# Access Compliance Report

## Public Rights-of-Way

### (Curb Ramps)

Intersection ID: 53095	Main Street: ALEXANDER_DOWD_DR	Cross Street: DEERFIELD_MANOR_DR	Location: W
ADA ID: 695A19AB09BB	Ramp Type: Perp	Initial Pass/Fail: Pass	Overall Compliance: No
Severity Score: 0			
Codes/Mitigation Info/Possible Solution		Field Measurements/Component Compliance

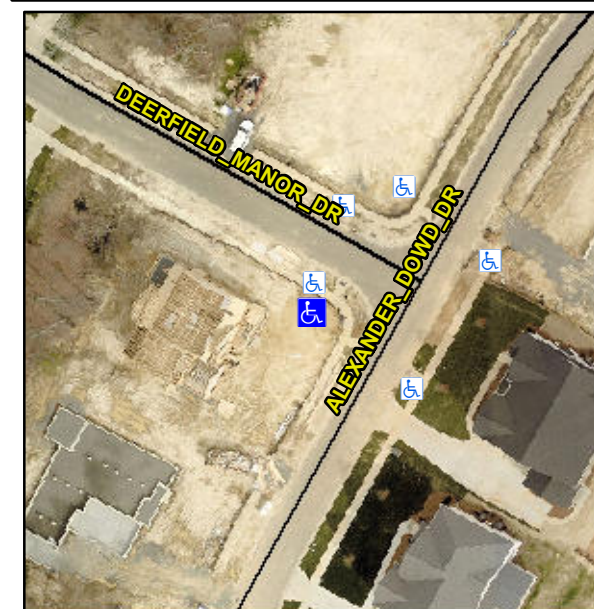
**R304.2.1, R305.2**

Compliance	Description	Data	Compliance	Description	Data
N/A	Ramp Length (in)	95.0	Yes	Ramp Slope (%)	5.1
Yes	Ramp Width (in)	48.0	Yes	Ramp XSlope (%)	0.6
N/A	Flare Type LT	Sloped	N/A	Flare Type RT	N/A
N/A	Flare Slope LT (%)	3.5	Yes	Flare Slope RT (%)	6.2
N/A	Flare Traversable LT?	Yes	N/A	Flare Traversable RT?	Yes
Yes	Landing Length (in)	59.0	Yes	DWS Provided?	Yes
No	Landing Width (in)	41.5	Yes	DWS Contrast?	Yes
Yes	Landing Slope (%)	1.4	Yes	DWS Length (in)	24.0
Yes	Landing X Slope (%)	0.6	Yes	DWS Full Width?	Yes
N/A	Landing Curb? (Y/N)	No	No	DWS Offset (in)	5.0
N/A	Shared Landing?	No			
Yes	Gutter Ponding?	No	Yes	Gutter Slope (%)	3.1
Yes	Gutter Lip Ht (in)	0.0	Yes	Gutter X Slope (%)	0.3
N/A	Painted X Walk1?	No	N/A	Painted X Walk2?	N/A
	X Walk 1 Direction	To SE		X Walk 2 Direction	N/A
N/A	X Walk 1 Width (in)	N/A	N/A	X Walk 2 Width (in)	N/A
	X Walk 1 Slope (%)	2.2		X Walk 2 Slope (%)	N/A
	X Walk 1 X Slope (%)	0.2		X Walk 2 X Slope (%)	N/A

N/A	Ramp inside XWalk1?	N/A	N/A	Ramp inside XWalk2?	N/A
	Road Slope (%)	N/A	N/A	Clear Space?	Yes
	Road X Slope (%)	N/A	N/A	Clear Space to XWalk (in)	N/A
Yes	Any Obstructions?	No	Yes	Storm Grate/Utility Hazard?	No
	Obstruction Type			Storm Grate/Utility Type	
		N/A			N/A
			Yes	Surface Condition? (G/P)	Good

**Remove & Replace Entire Ramp.**
